Groundwater Transfer Review Summary Form

Transfer/PA # T- 14466 (RA)

Application: T-14466 RA

Applicant Name: Eagle Eye Ventures LLC

Well Location Map

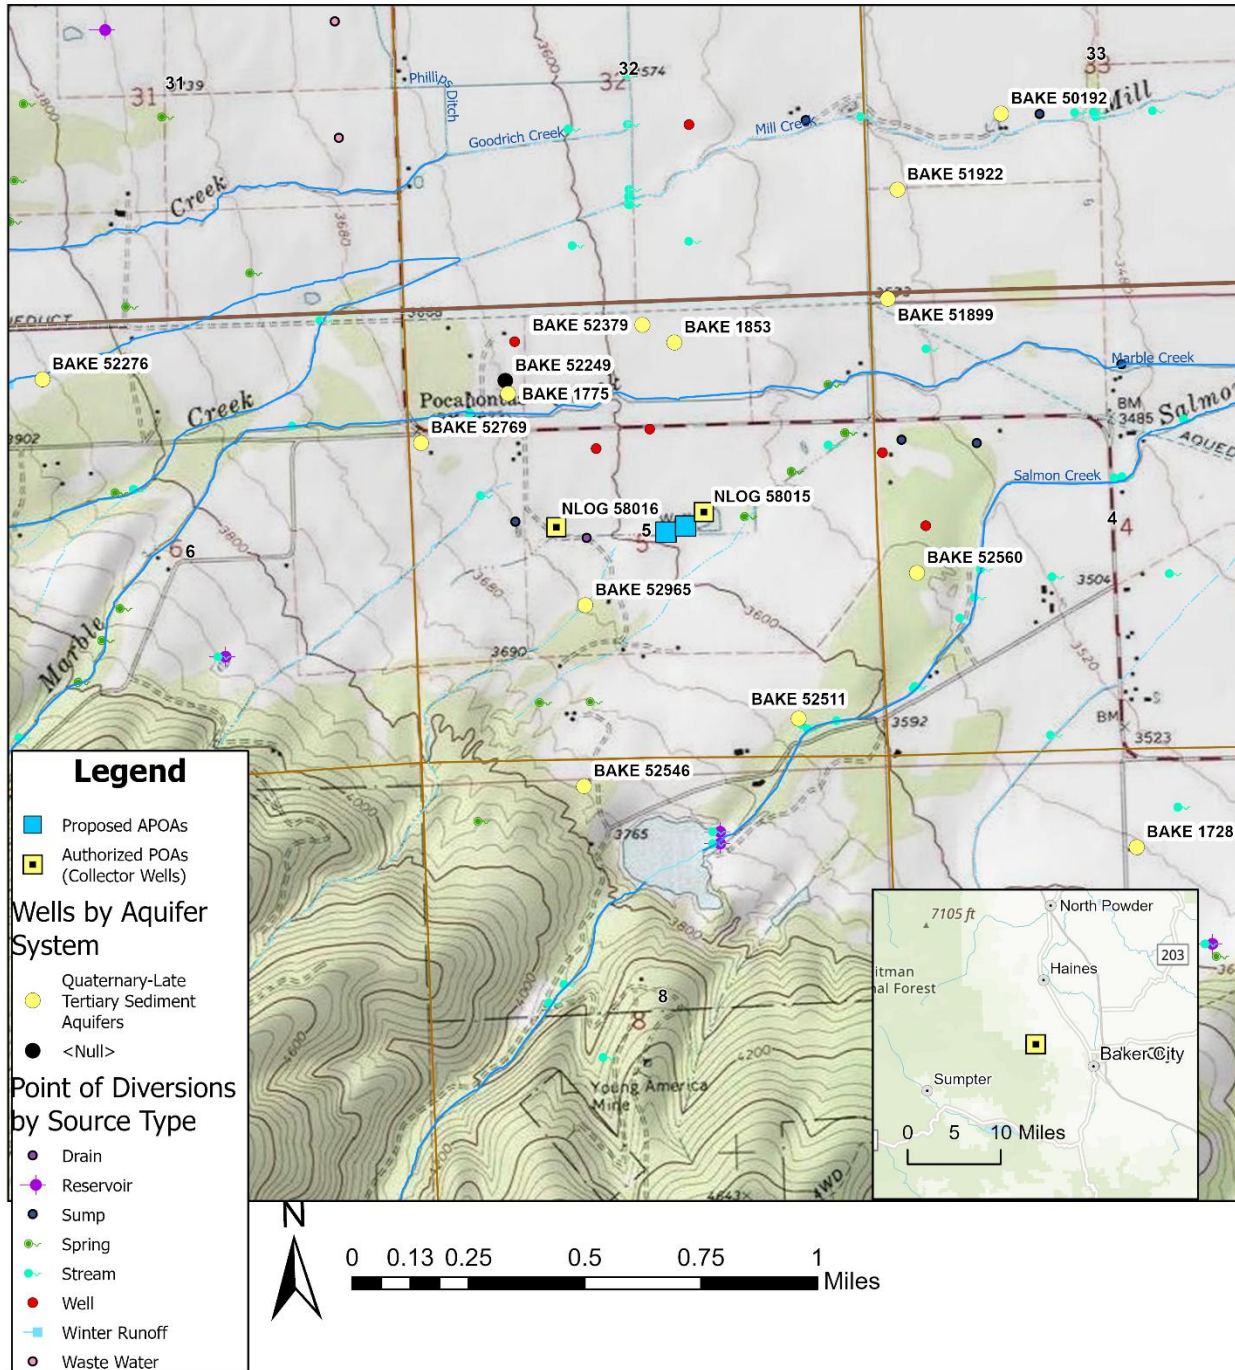
2. Will the proposed POA develop the same aquifer (source) as the existing authorized POA?
 Yes No Comments: The three existing groundwater POAs consist of horizontal collector wells, or “drain tiles”, buried 3 to 4 feet below the surface. The shallow depth of these POAs limits production to water in the near-surface (i.e. from springs and infiltrated irrigation), which limits their impact on groundwater levels in the underlying aquifer. In contrast, the two proposed APOA wells would be about 50 feet deep, sealed to roughly 20 feet below the surface, and would draw water directly from the alluvial aquifer. Because these proposed POAs would not be restricted to near-surface water, they would likely cause greater drawdown in the aquifer. If the applicant’s authorized POAs are no longer producing their authorized volume of water, the proposed APOAs could result in enlargement. This enlargement could further lower groundwater levels and reduce groundwater discharge to nearby surface waters.

5. a) Will this proposed change, at its maximum allowed rate of use, likely result in an increase in interference with **another ground water right**?
 Yes No Comments: The closest known well completed in the shallow alluvial aquifer is BAKE 52810, located approximately 2,000 feet northeast of proposed Well 5. The proposed APOAs may obtain water from the same aquifer developed by BAKE 52810. The deeper open interval (20 to 50 feet bls) of the proposed APOAs compared to the shallow open interval of the authorized POAs (3 to 5 feet bls) will result in greater drawdown in the alluvial aquifer and increased potential for interference with BAKE 52810. BAKE 52810 is an exempt livestock well completed to 200 feet bls with a reported static water level of 35 feet bls at the time of drilling in November 2021.

Theis Interference Analysis – Proposed APOAs to BAKE 52810

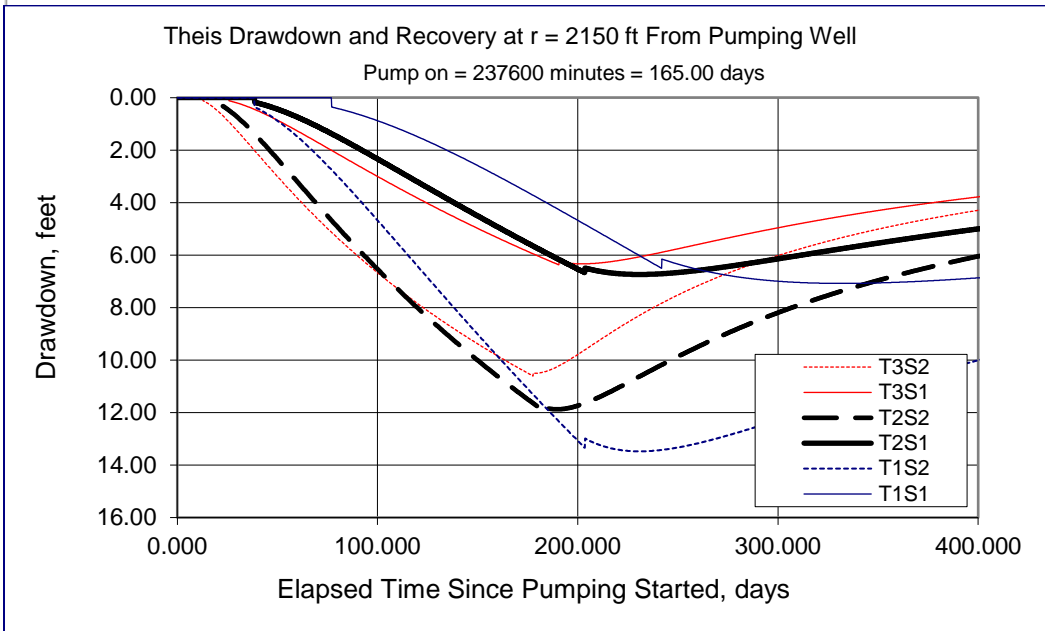
- b) If yes, would this proposed change, at its maximum allowed rate of use, likely result in another groundwater right not receiving the water to which it is legally entitled?
 Yes No If yes, explain: The Theis (1935) solution for drawdown in a confined aquifer was used to assess potential injury at BAKE 52810 and other nearby wells from pumping at the proposed APOAs. Assuming a range of hydraulic parameters typical for poorly sorted alluvial fan/terrace sediments, the analysis indicates that drawdown at BAKE 52810 would likely be less than 15 feet after 61 days of continuous pumping at the maximum proposed rate of 5.46 cfs to reach the full duty under Certificates 73168 and 73169. However, based on reported well yields in the area, it is unlikely that the combined yield of the proposed APOAs would exceed 2.0 cfs. Well reports show a median yield of 20 gpm and a maximum yield of 50 gpm. Assuming a maximum combined pumping rate of 2.0 cfs, the estimated interference at BAKE 52810 would be less than 14 feet after 165 days of continuous pumping. The proposed change is not expected to result in substantial or undue interference at BAKE 52810 or other nearby groundwater users.
